PLANNING COMMISSION
Tuesday, August 14, 2018
265 Strand Street, St. Helens, OR 97051
www.ci.st-helens.or.us

City of St. Helens Planning Commission

**CITY OF ST. HELENS PLANNING DEPARTMENT
STAFF REPORT
Access Variance V.3.18**

V.3.18
site plan

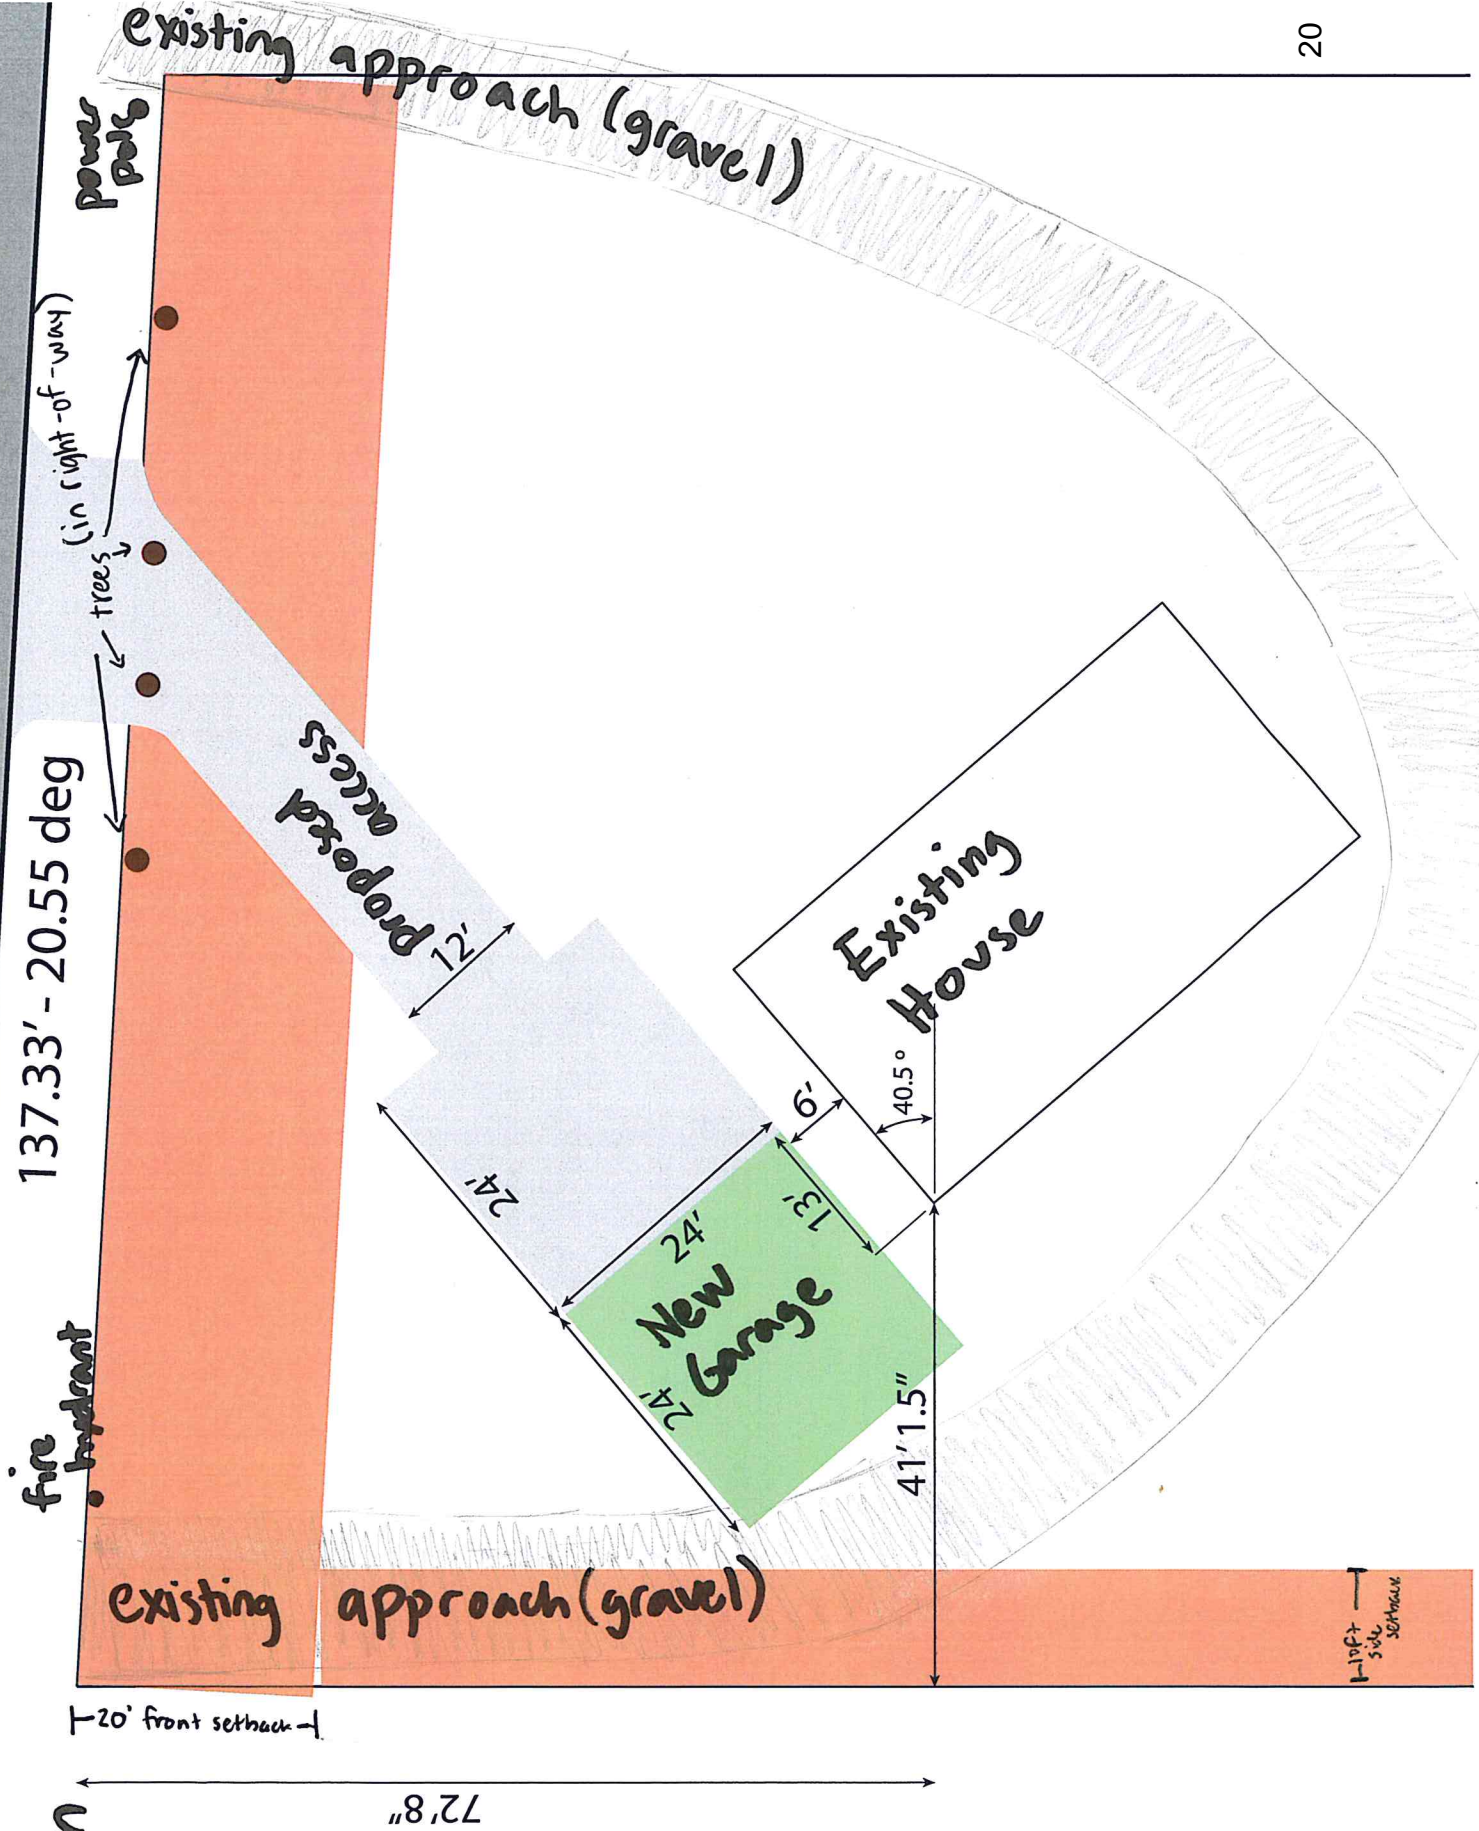
- The Commission needs to determine if this criterion is met to approve the variance or approve it with conditions.
- See applicant's narrative.
- Staff comment(s): It appears that the neighbor and the applicant used an informal shared access, which functioned historically as the applicant's secondary driveway approach.

- The Commission needs to determine if this criterion is met to approve the variance or approve it with conditions.
- See applicant's narrative.
- Staff comment(s): There are some factors that limit the placement of alternative driveway approaches, including a power pole, a fire hydrant, mature trees, and the odd positioning and placement of the house. The applicant states that building a new accessory structure will make it difficult to use the existing driveway approach to maneuver their vehicles to prevent backing movements onto Pittsburg Road.

- The Commission needs to determine if this criterion is met to approve the variance or approve it with conditions.
- See applicant's narrative.
- Staff comment(s): The access separation requirements are not currently met with either of the two existing driveway approaches. They are closer than 200 feet from each other and from the neighbor's existing driveway approach.

- The Commission needs to determine if this criterion is met to approve the variance or approve it with conditions.
- See applicant's narrative.
- Staff comment(s): The applicant wishes to build a garage next to the house. The angled placement of the house creates challenges for designing a driveway to the new garage that allows for vehicular maneuvering to prevent backward movements onto Pittsburg Road.

- See applicant's narrative.
- Staff comment(s): Once the new garage is built, the applicant indicates they will be unable to adequately turn their vehicle around to enter Pittsburg Road. This implies that the new driveway approach is needed for safer access.

- The Commission needs to decide if allowing the applicant to keep one of the existing driveway approaches and a build a new one is the minimum variance necessary to provide adequate access and eliminate backward maneuvering onto Pittsburg Road.

- The Commission needs to determine if this criterion is met to approve the variance or approve it with conditions.
- See applicant's narrative.
- Staff comment(s): The applicant is proposing to remove the secondary driveway approach that is partially, if not entirely, located on the neighbor's property. Since there were previously two approaches that did not meet the spacing standards, approving this variance will not result in a greater degradation of the transportation system than was existing prior to this variance.
- Per SHMC 17.84.060 (3) only local streets are allowed to have driveways that require or facilitate backward movement or maneuvering in the street. This is particularly important along an Arterial classified street like Pittsburg Road.

Based on the facts and findings herein, if the Planning Commission approves the Access Variance for a second driveway approach that does not meet the access spacing standard, staff recommends the following conditions:

1. This Access Variance approval shall be valid for one-and-one-half year (SHMC 17.84.140).
2. This Access Variance shall become void unless the following occurs within the validity period:

An access permit for the proposed and existing “first access point” is obtained from the County Road Department with the following required as conditions of approval from the City, in addition to any County requirements:

- a. The first 25 feet (depth) of the new driveway access shall be paved as required by SHMC17.80.050(10)(iii); and
 - b. The existing “second access point” shall be removed or rendered unusable for the subject property as approved by the City and County.
3. At the time of development of a new building that utilizes the subject property’s driveways, the existing gravel portion that remains if any (i.e., all areas used for the parking, storage, or maneuvering of an vehicle, boat, or trailer) shall be improved with asphalt or concrete as required by SHMC 17.80.050(10)(a).
 4. Because Pittsburg Road is a County facility, this Variance is contingent on County approval for access. For example, County denial of the access point approved by this Access Variance, shall render this Access Variance void.

SDR4

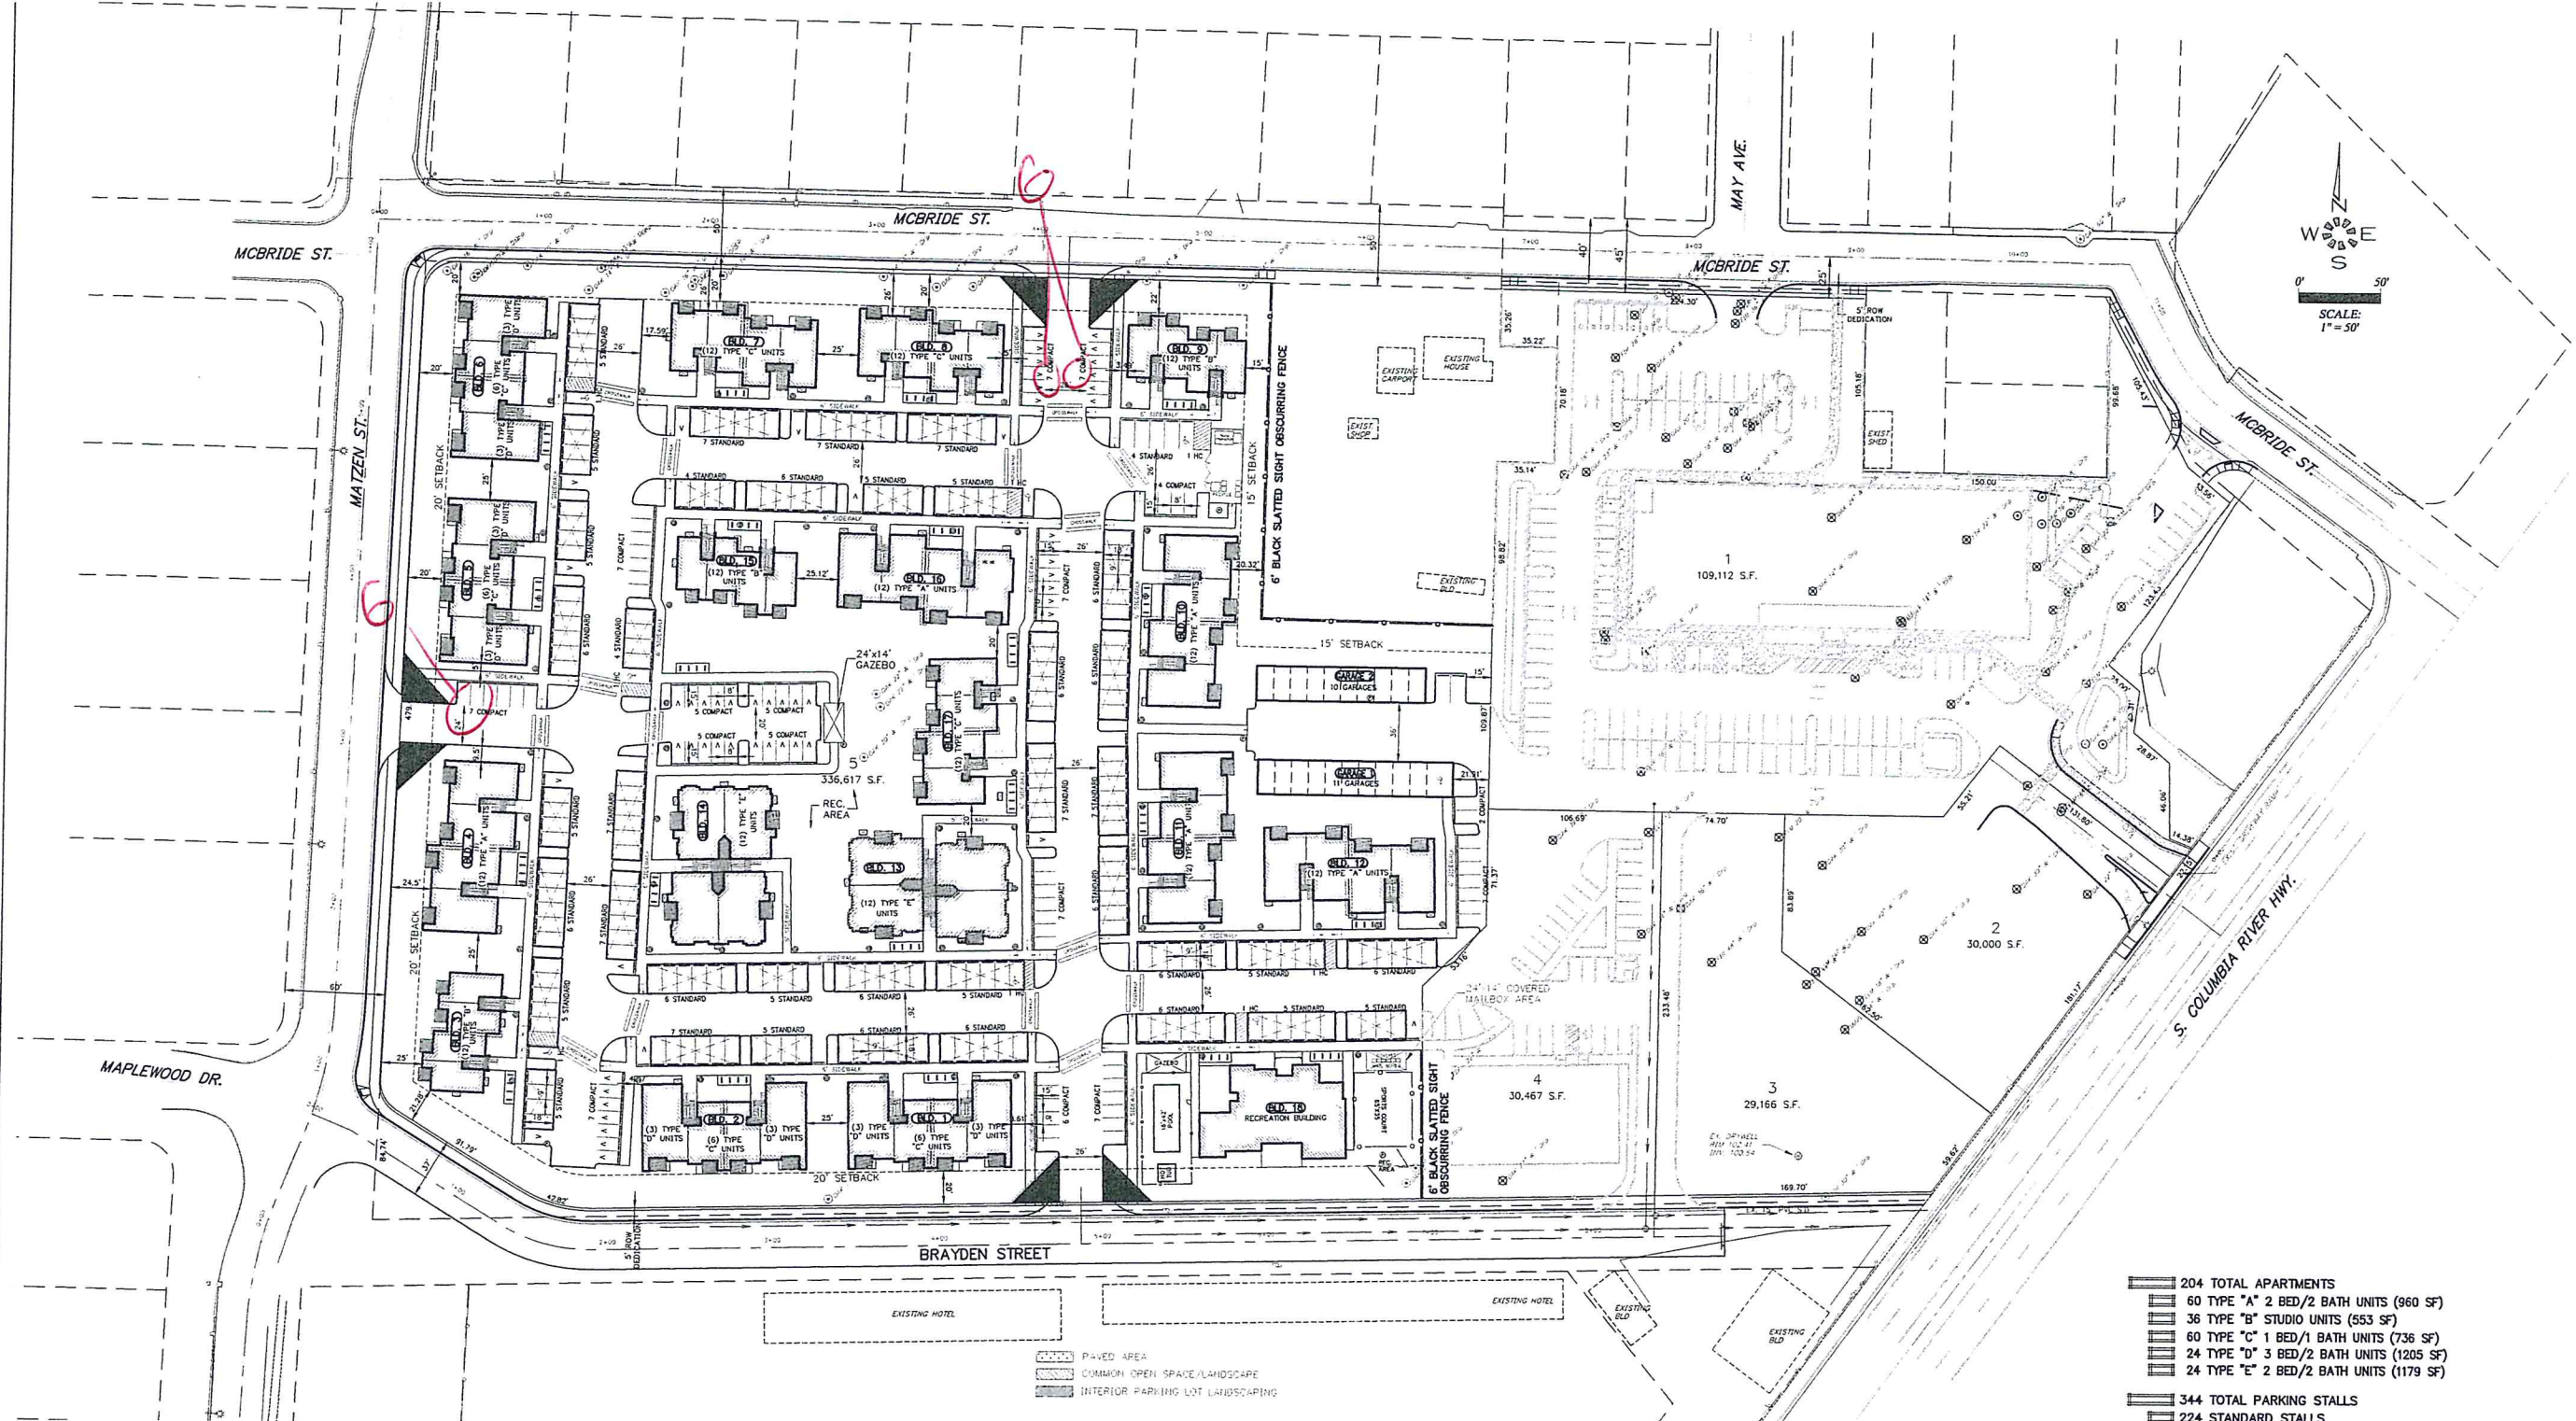
Proposal as shown on the site plans (sheet SDR4) is about 20' x 44' or about 880 square feet, which is insufficient. On sheet SDR5 its shown as 25' x 45' or about 1,125. Plans are inconsistent.

A9.1

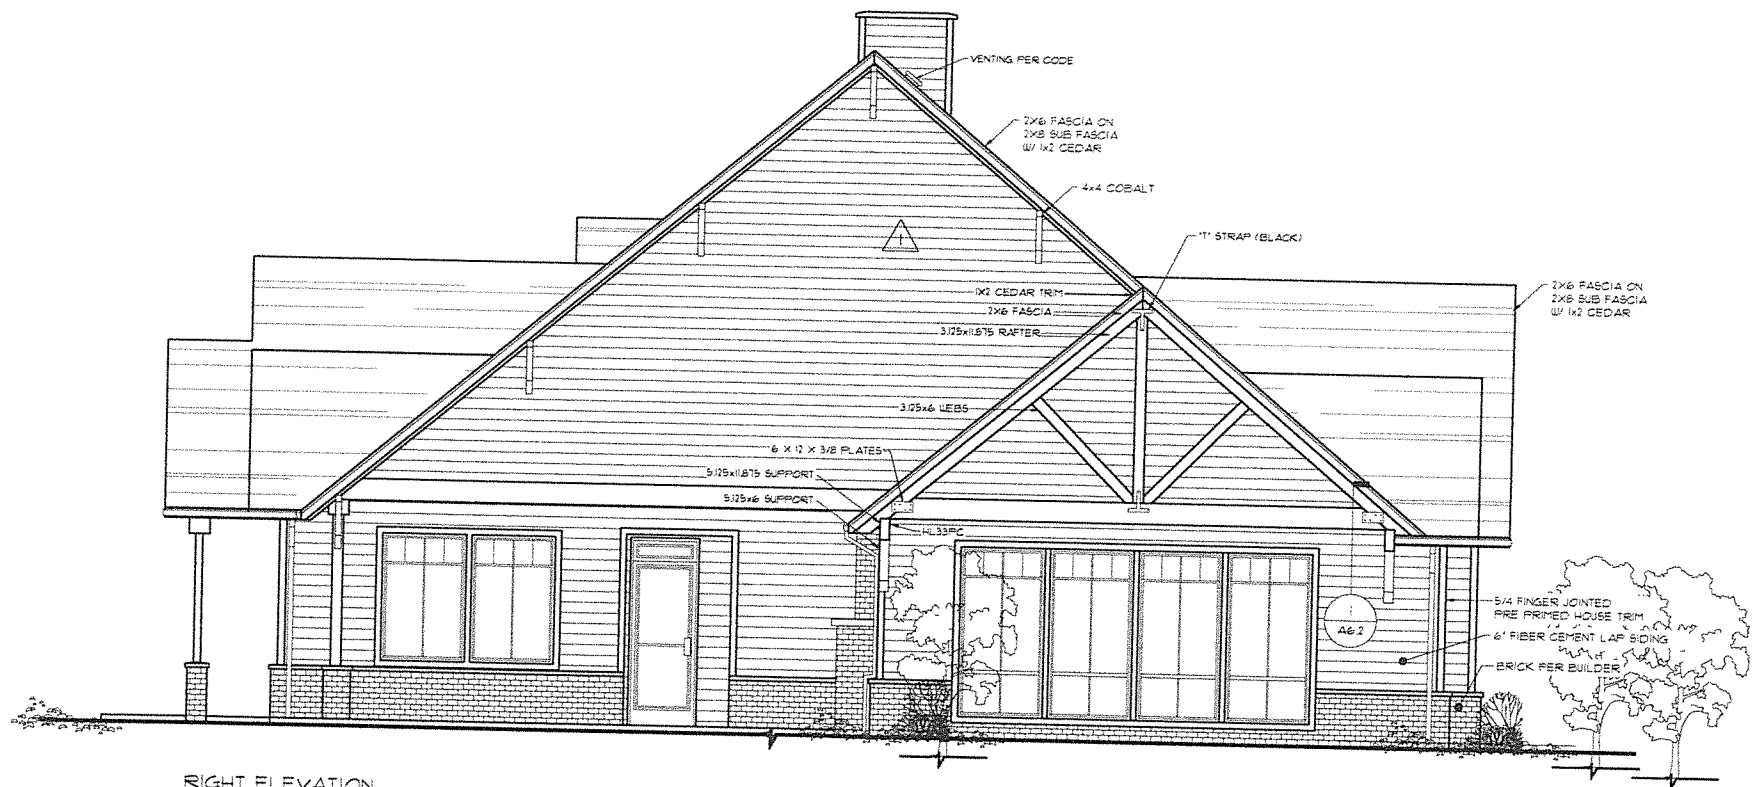
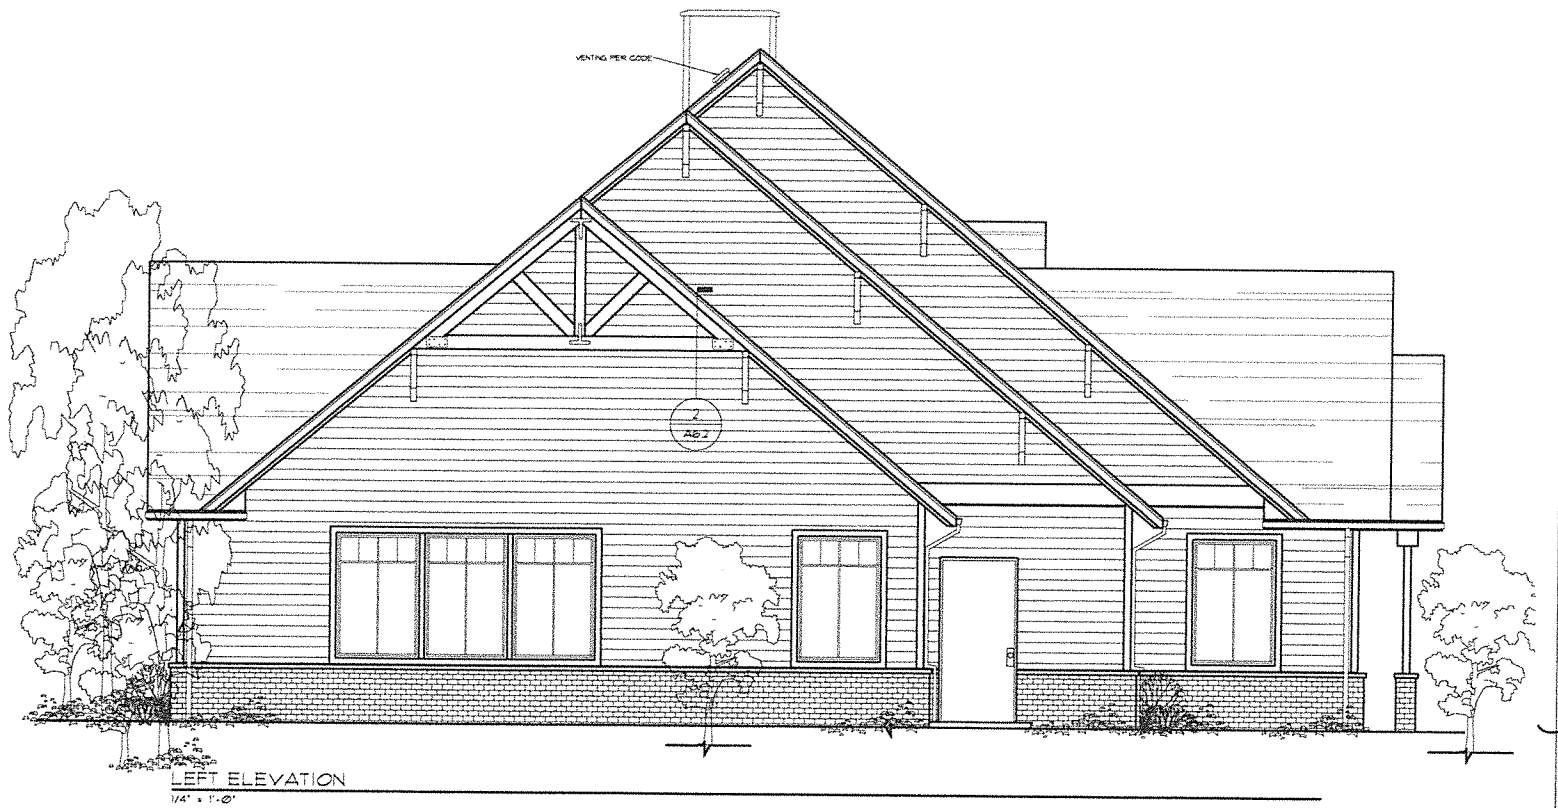
Zoning Compliance: The site is zoned General Commercial, GC. The main focus of this is the multidwelling unit proposal. But there is also a business rental area located within the proposed recreation building too (sheet A9.1), the proposed use of which is not stated by the applicant.

Also, two spaces are proposed for the recreation building which includes a rental area (see sheet A9.1).

If the additional parking is not required for the “business rental” identified on sheet A9.1, the proposal is 4-spaces deficient. Otherwise, it could be considered more deficient.
